# CITY PLANNING COMMISSION

APPLICATION: Special Permit to develop a 47 space parking garage in the C-3 zone in conjunction with a six story office building.

LOCATION: Southeast corner of 12th and H Streets.

APPLC. NO. P-8995

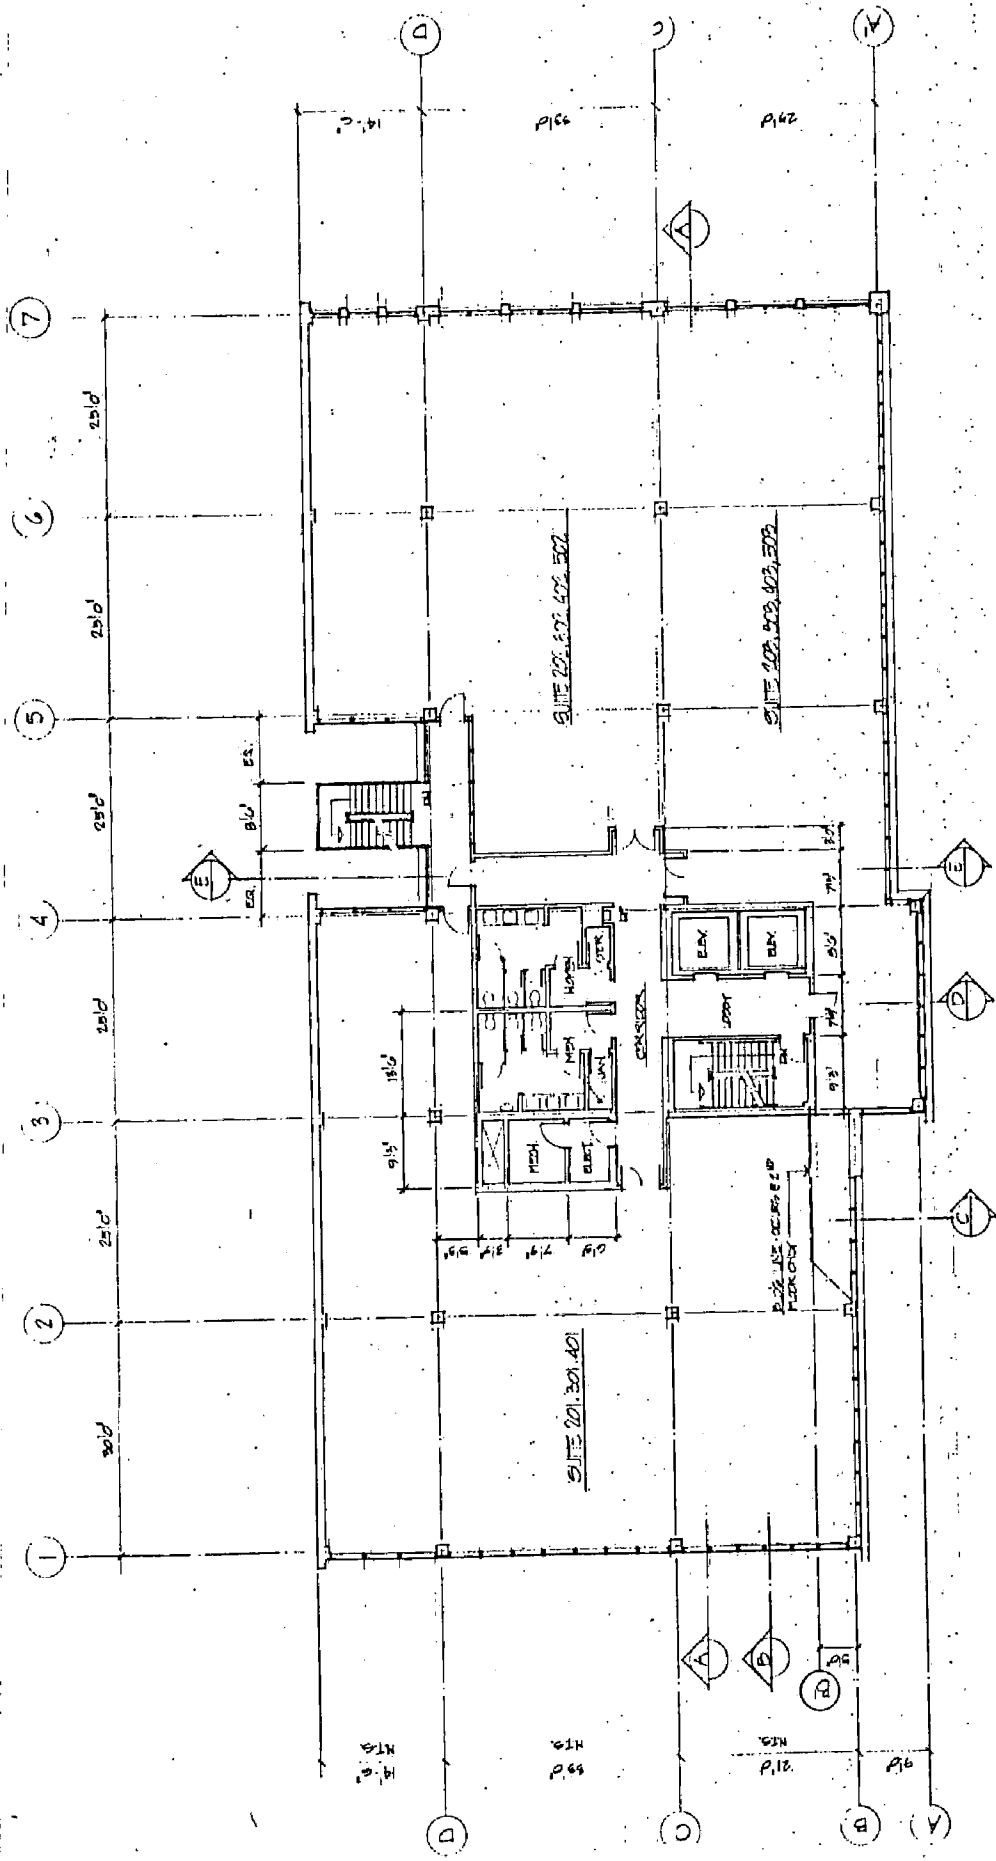
1. The submitted site plan indicates a 2-1/2 foot planter adjacent to the parking garage along 12th Street and a 3 foot planter along H Street. The Zoning Ordinance requires a 4 foot planter adjacent to paved parking areas. Therefore, the staff suggests:

- a. The planters be increased to 4 feet in width, or
  - b. The applicant request a variance to allow a portion of the required 4 foot planter to extend onto City right-of-way.

1. The proposed planting strip adjacent to the metal lattice shall be a minimum of 4 feet in width.
2. Subject to review and approval by the Architectural Review Board with specific design reference to:
  - a. the metal lattice elements relationship to the building design.
  - b. the compatibility of the horizontal metal skin.
  - c. the brick paving material on the 12th Street sidewalk.
  - d. the landscaping material.
3. A bicycle storage area shall be designed in the parking garage.

H<sup>ST</sup> ELEVATION  
E. 10'-10"

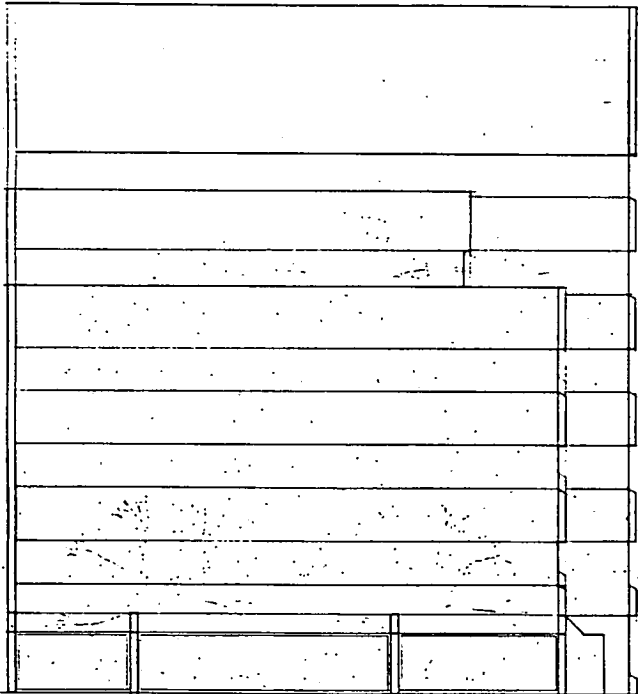
2. Design Consideration - The staff suggests the Architectural Review Board review the following:
  - a. The metal lattice and how it relates to the building design.

- b. The compatibility of the horizontal metal skin with surrounding properties.
  - c. The texture of the block material on the east elevation.
  - d. The brick paving material on the 12th Street sidewalk should be a non-slippery surface.
